# UNITED STATES PATENT AND TRADEMARK OFFICE

APPLICATION NO.	FILING DATE	FIRST NAMED INVENTOR	ATTORNEY DOCKET NO.	CONFIRMATION NO.
10/717,256	11/19/2003	Erich Schwaerzler	12761/293065	7703
7590	05/18/2006		EXAMINER	
John M. Harrington Kilpatrick Stockton LLP 1001 West Fourth Street Winston-Salem, NC 27101			HAWK, NOAH CHANDLER	
			ART UNIT	PAPER NUMBER
			3636

<b>Office Action Summary</b>	<b>Application No.</b>	<b>Applicant(s)</b>	
	10/717,256	SCHWAERZLER ET AL.	
	<b>Examiner</b>	<b>Art Unit</b>	
	Noah C. Hawk	3636

## DETAILED ACTION

Delmege et al., Figure 2

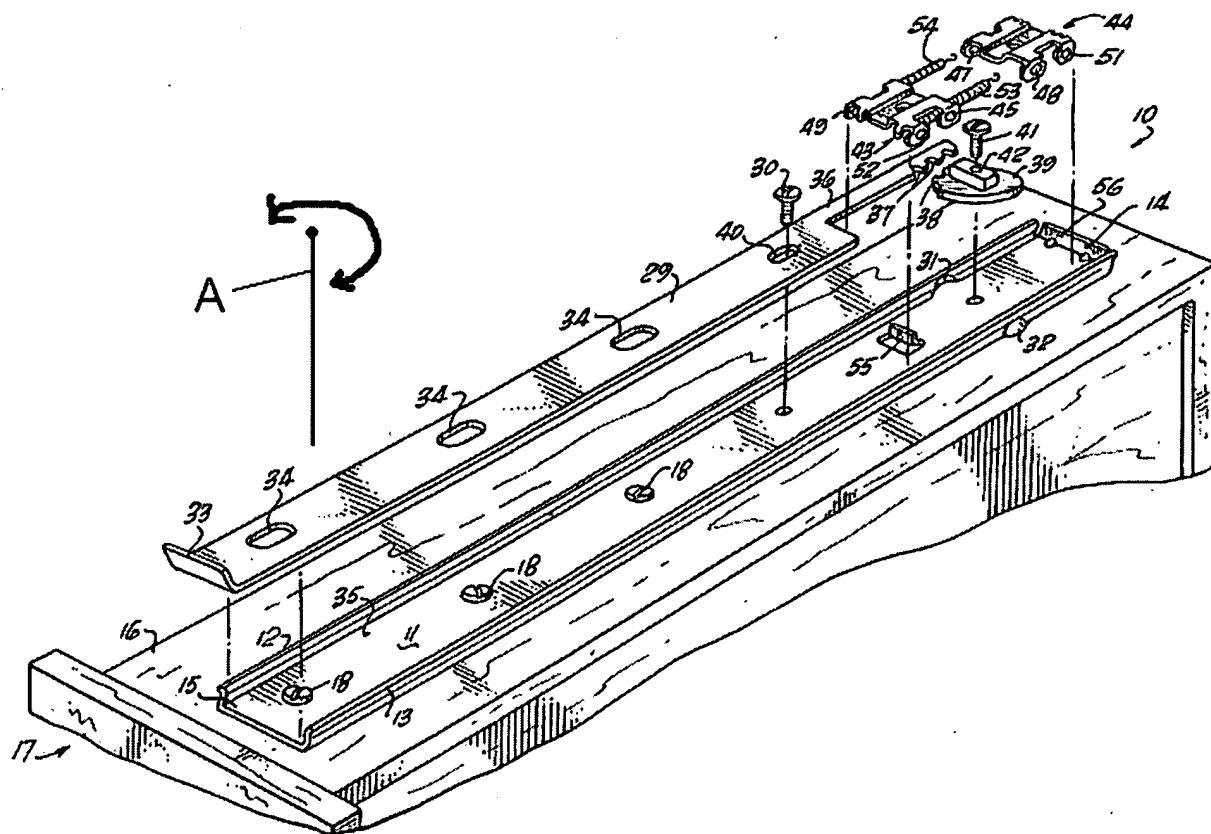
a. Regarding Claim 1, Delmege et al. disclose a panel adjustment device as structurally claimed for a drawer having a front panel and mounted in a drawer opening of a cabinet by means of a rail system with at least one each of a drawer rail (11) and a cabinet rail (19), the panel adjustment device comprising a lifting and lowering device (the combination of 29, 33, 36, 41, and 39) located between the drawer and the drawer rail to swivel the drawer relative to the drawer rail about a swiveling axis (A) which is closer to the front of the drawer than the rear, the lifting and lowering device further comprising a lifting and lowering element (39) to swivel the drawer. Please note: the limitations "operable for changing an enclosed inclination angle defined between a front side of the drawer opening of the cabinet and the front panel of the drawer" and "being operable to urge the drawer with the front panel attached to the drawer to swivel relative to the drawer rail about the swiveling axis resulting in a corresponding change in the enclosed

inclination angle defined between the front panel of the drawer and the front side of the drawer opening" are considered functional language and are not given any patentable weight.

b. Regarding Claim 2, Delmege et al. further disclose a panel adjustment device wherein the swiveling axis (A) is closer to the front panel of the drawer than to the lifting and lowering element of the lifting and lowering device (best seen in Delmege et al., Figure 2).

3. Claim 16 is rejected under 35 U.S.C. 102(b) as being anticipated by Delmege et al. Delmege et al. disclose a panel adjustment device as structurally claimed for a drawer equipped having a front panel and mounted in a drawer opening of a cabinet and supported on by means of a rail system with at least one each of a drawer rail (11) and a cabinet rail (19) which panel adjustment device is suitable for changing an enclosed inclination angle between the front of the opening and the drawer, the panel adjustment device comprising a lifting and lowering device (the combination of 29, 33, 36, 41, and 39) that operates between the drawer and the drawer rail to swivel the drawer relative to the drawer rail about a swiveling axis, the lifting and lowering device further comprising a slider (the combination of 33, 29 and 36) and a lifting and lowering element (39) so that a swiveling of the drawer and with it, the front panel of the drawer is made possible around the swiveling axis (A) and wherein the slider is formed out of a flat material (best seen in Delmege et al., Figure 2) which extends from a front area of

the drawer rail to a back area of the drawer rail and is held movable in the front area of the drawer rail up to a center area on a horizontal shank (18) of a side wall lower component of the drawer and wherein the slider has a rear area (36) that is supported on the drawer rail with an end (37) of the slider formed as a wedge-shaped sliding piece. Please note: the limitations "operable for changing an enclosed inclination angle defined between a front side of the drawer opening of the cabinet and the front panel of the drawer" and "being operable to urge the drawer with the front panel attached to the drawer to swivel relative to the drawer rail around the swiveling axis" are considered functional language and are not given any patentable weight.
